RotorSport UK Ltd

Service Bulletin

SB No.: 023 issue 1	CCAR No.: None	Classification:
Aircraft type & model (applicability) RotorSport UK MTOsport, MT-03 if retrofitted with MTOS enclosure	Aircraft serial Nos. effected RSUK/MTOsport all, MT-03 if retrofitted with MTOS enclosure	OPTIONAL or RECOMMENDED or MANDATORY

The halogen landing lights fitted to the nose of MTOsport aircraft (or MT-03 retrofitted with MTOS enclosure) are accessible inside the nose luggage locker. After a long period of use these lights become hot and could cause damage to luggage. The connectors could also be dislodged when loading the luggage.

Landing light location inside nose (tension spring retention is shown)

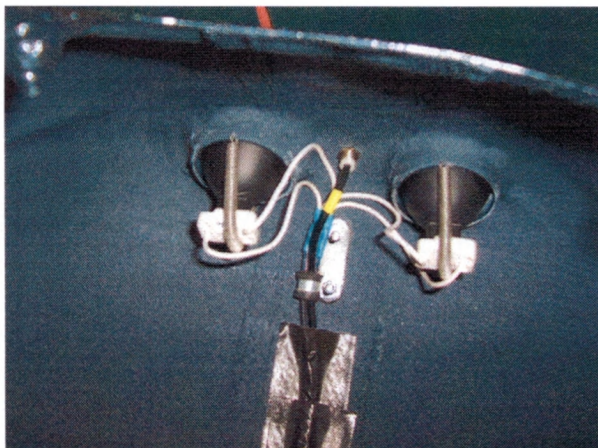
1. Remove the luggage hatch. Examine the landing lights to confirm that the lamp units are secure and the cable connectors properly fitted. NB: lamp retention may be by circlips (accessible outside the nose) or by tension springs (accessible through the hatch).

Shield offered-up over aft-most stud

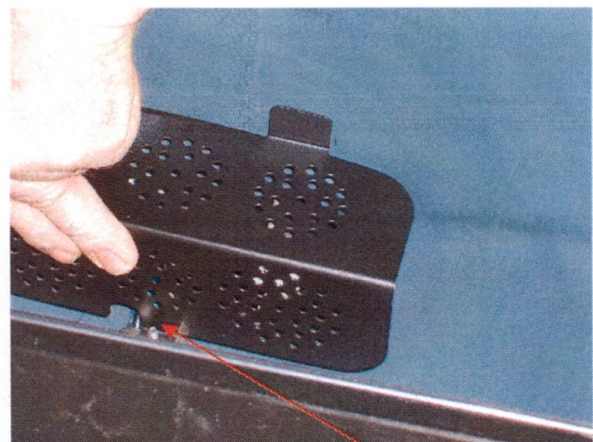
2. Offer-up the shield over the aft-most stud that retains the tie-down loop and mark-out the position of the two tabs on the enclosure. Verify that the electrical cables are clear of contact with the shield edge.

Velcro pads in place

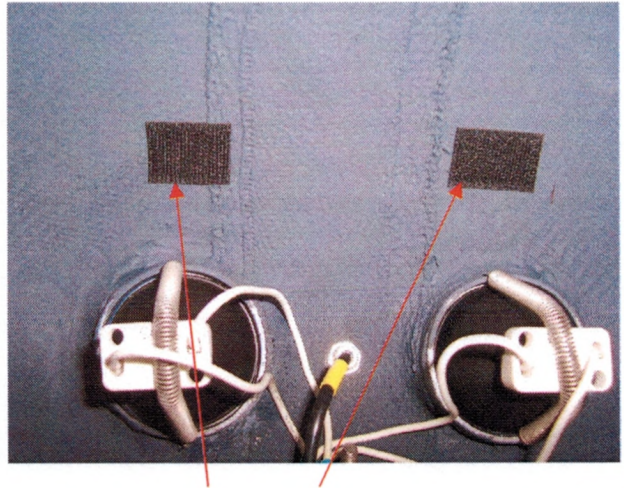
3. Remove the shield, clean the enclosure contact surface with Amberklene LO30 (or equivalent) and attach the two Velcro pads (hook side) to the marked areas on the enclosure.

Push onto Velcro then fit washer and nut to stud

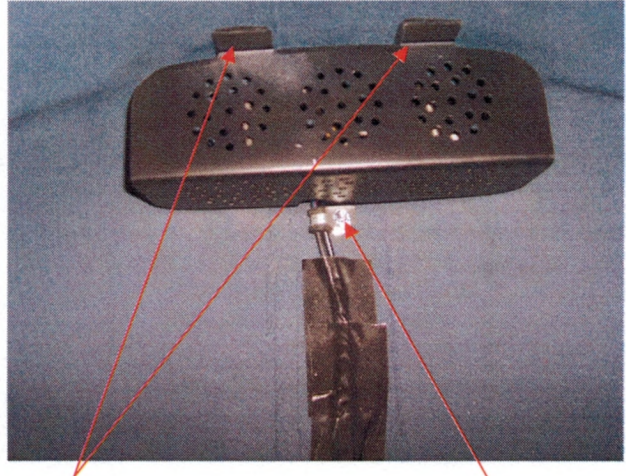
4. Replace the shield, press the Velcro into place and fit an M5 plain washer and M5 nyloc nut to the protruding stud. Tighten the nut using a socket/extension (hand-tight 2Nm). Refit the hatch cover ensuring all four fasteners engaged.
